224-252 La Trobe Street, Melbourne

Planning Permit Application 2014/000770

Figure 2 – Equitable Development Study

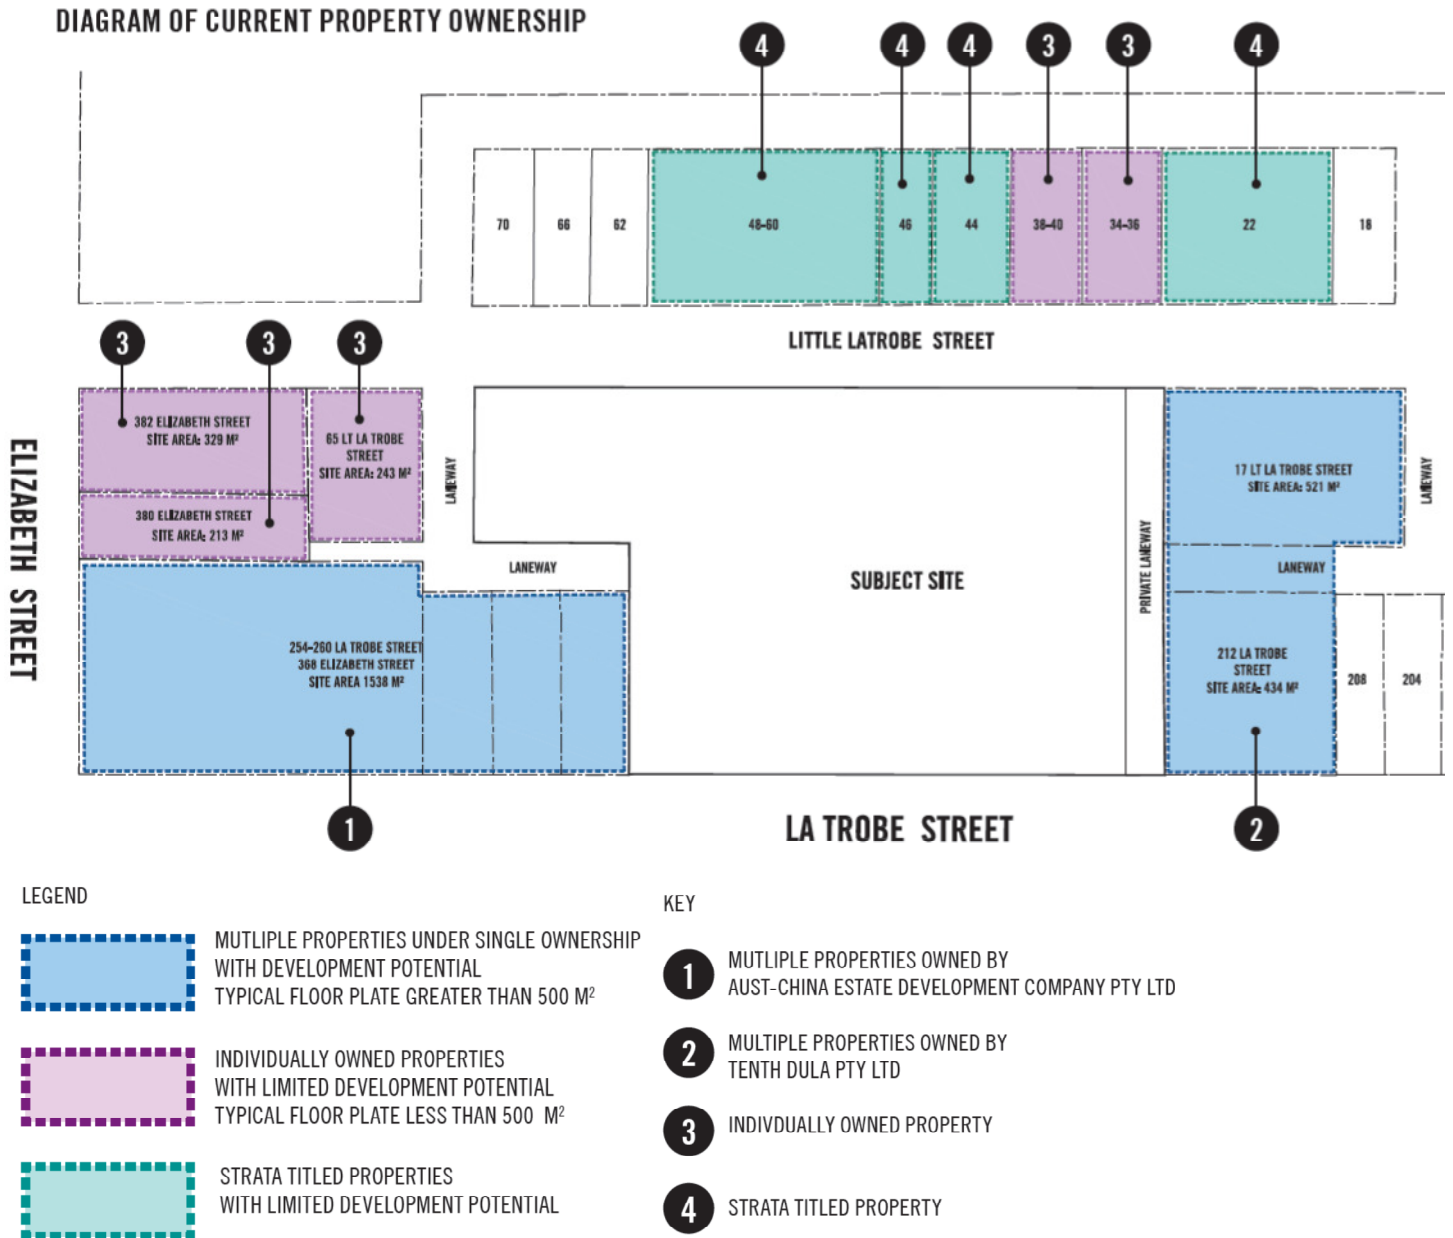
The site is directly abutted to the east and west. Tower separation is less than 24 metres stipulated in Clause 22.01. Policy allows a reduction in tower separation where it can be demonstrated that the towers are offset and habitable room windows do not directly face one another and where the redevelopment of adjoining sites is not compromised.

The proposal provides a minimum tower setback of 7.5 metres and 6.5 metres to the respective east and west common boundaries. This demonstrated the development potential of the adjoining sites has been considered and will allow for adequate separation, of a minimum tower separation east and west of the site of 12.5 metres and 11.5 metres respectively, between the proposed tower and

possible future tower developments on the adjoining sites. Refer to **Figure 2** below for an analysis of the likely redevelopment opportunities to surrounding sites. It is noted that the adjoining site at 212-222 La Trobe Street was refused and is subject to review by VCAT (no hearing date set as yet). If this is approved it will be tower separation of 12.5 metres between the two towers and this is considered to be appropriate as both include strategies to orientate views away from the shared boundary.
